LaSalle County Station, Units 1 and 2
Facility Operating License Nos. NPF-11 and NPF-18
NRC Docket Nos. 50-373 and 50-374

Subject: Additional Information Supporting Request for License Amendment Regarding Spent Fuel Storage Pool Criticality

ATTACHMENT 1
Response to Request for Additional Information

Figure 1: Examples of Implementing the 3-of-4 and 4-of-4 Interface Configurations

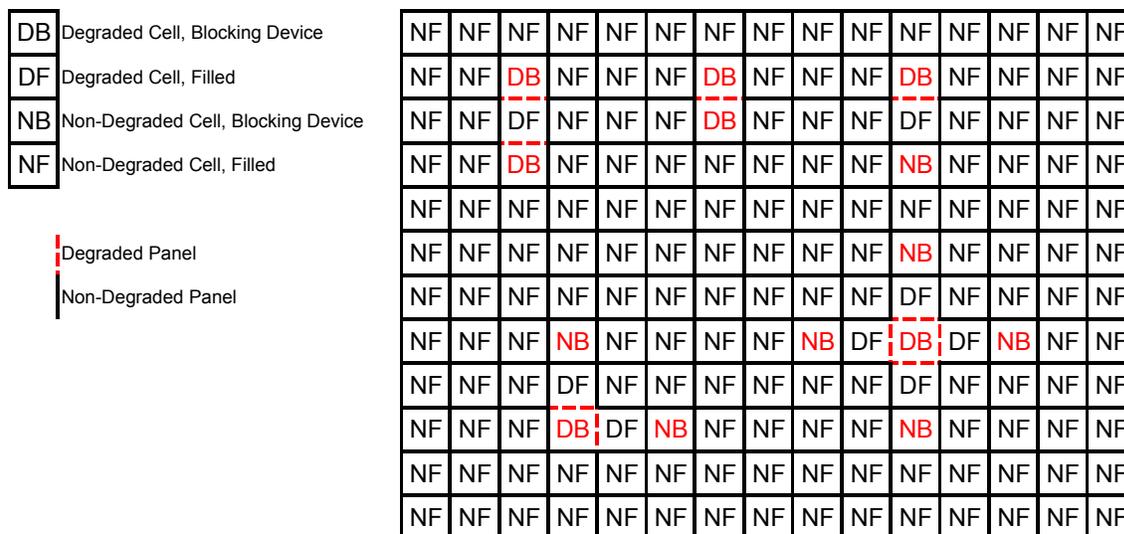
It is not clear that all of the affected 2x2 arrays are being identified. A storage cell is not part of just one 2x2 array. Unless it is on the periphery, each storage cell is at the center of a 3x3 array which comprises four different 2x2 arrays. Additionally, from the description in the LAR, it appears that the Boraflex panels are shared by two cells, meaning the degradation of one panel actually affects two cells, creating a 4-by-3 array of cells with six separate 2x2 arrays. It is not clear whether the adjacent cell is also being identified as 'unusable' and its associated 2x2 arrays being controlled. Provide a description of how the affected 2x2 arrays are being identified and controlled so that the staff may make a reasonable assurance decision that all of the appropriate affected 2x2 arrays are being included.

A single degraded storage panel causes two degraded storage cells, which are then part of six 2x2 arrays. Each of these 2x2 arrays must satisfy the acceptance criteria for either 3-of-4 or 4-of-4 storage. There is no need to consider the 3x3 array with the degraded cell in the center as satisfying the conditions for each 2x2 set of cells that contains a degraded cell is sufficient.

Therefore, in each of the six 2x2 arrays that can be considered containing a degraded storage cell, there must be a blocking device in one of those four cells. In such a configuration, a minimum of two blocking devices would be required (i.e., most likely placed face adjacent to the degraded panel but not necessarily placed face to face as shown below) to satisfy the 3-of-4 storage criteria for each of the six 2x2 arrays created by the degraded panel.

Figure 1 provides several other configurations of degraded storage cells and the requirements for blocking devices. In the figure below, panels that exhibit an unacceptable level of Boraflex are designated by a dashed line. Boraflex panels that do not exhibit an unacceptable level of

Boraflex are designated by a solid black line. The first letter in each cell specifies whether a storage cell is considered degraded (D) or not degraded (N). A storage cell is considered degraded if one or more of the four surrounding Boraflex panels are considered degraded to an unacceptable level. The second letter in each cell specifies whether the storage cell contains a blocking device (B) or is filled with spent fuel (F).

Figure 3: Calculational Model of Eccentric Positioning as Drawn by the Two-Dimensional Plotter in MCNP4a

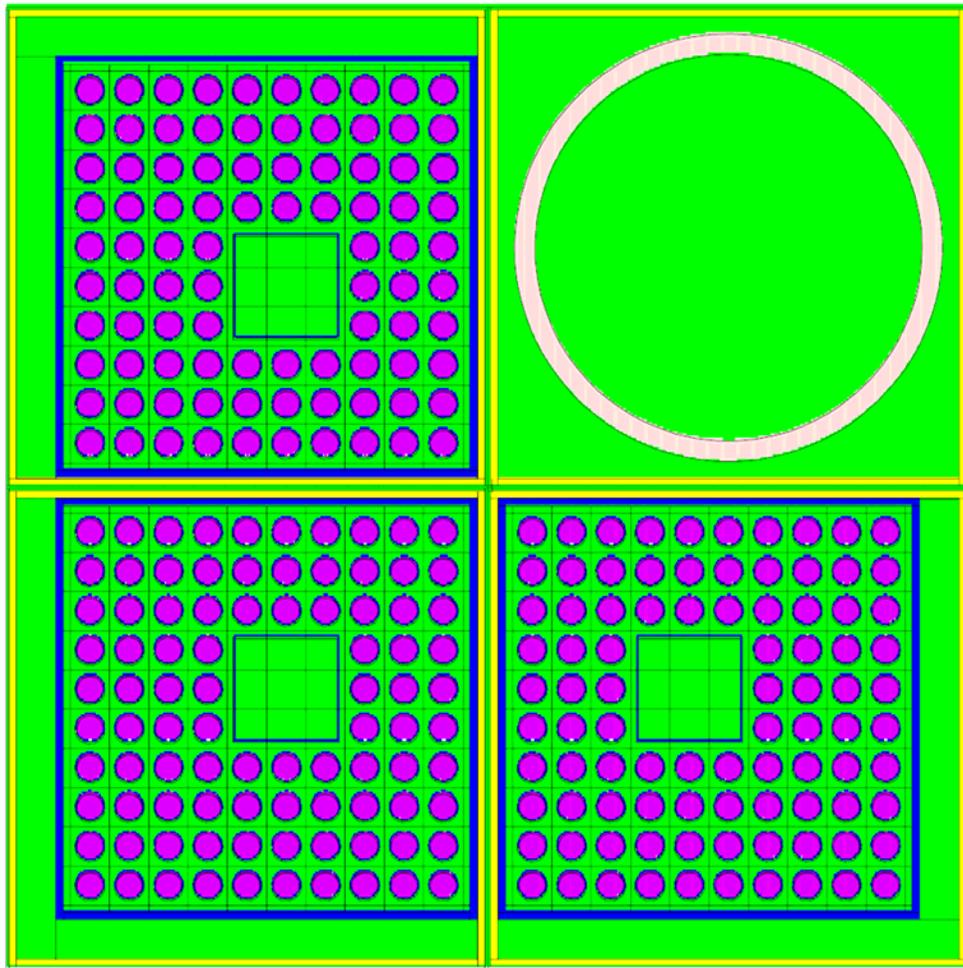
- a) The nominal calculations have the FA centered in the cell. For the eccentric positioning determination the analysis states, "MCNP-4A calculations were made with the fuel assemblies assumed to be in the corner of the storage rack cell. These calculations indicate that eccentric positioning results in a decrease in reactivity." The discussion leaves out several pertinent details. Are they all pushed into the same corner? That would essentially keep the distance between them constant. Are they all pushed into the corner which brings them closest together? Since it is a 2x2 array modeled as infinite, even that essentially keeps the net separation the same. What if not all of the assemblies are pushed into the corner? Does it matter which ones are? What if the 3-of-4 storage configuration is surrounded by 4-of-4 storage configurations, or vice versa? Provide the necessary details for the staff to independently reach a reasonable assurance determination regarding eccentric fuel positioning.

- b) The analysis concludes that centering the fuel assemblies in the cells is the most reactive configuration. Since the channel takes up space in the cell it effectively reduces the amount of eccentricity that can be achieved by the model. Would increased eccentricity affect the conclusion? Are these independent parameters?

The eccentric positioning calculations consider that each group of three assemblies (i.e., 2x2) is clustered together as shown in Figure 3 below. Periodic boundary conditions simulate an infinite array of eccentrically located fuel assemblies, clustered in groups of three. The blocking device is not considered to be eccentrically positioned because movement of the blocking device within the cell would have a negligible effect on reactivity. Eccentric positioning does not result in an increase in reactivity because although the assemblies are placed closer to one another in one location, it creates a larger water gap between other adjacent assemblies. The distribution of 3-of-4 and 4-of-4 storage patterns in the SFP would not effect the conclusion that eccentric positioning does not increase the reactivity.

The presence of the channel would restrict the amount of eccentricity possible. However it should be noted that the absence of the channel would result in a decrease in the reactivity by 0.0076 Δk . Any reactivity effect of additional eccentricity because of the missing fuel channel is not expected to have any additional reactivity effect and would be offset by the absence of the channel.
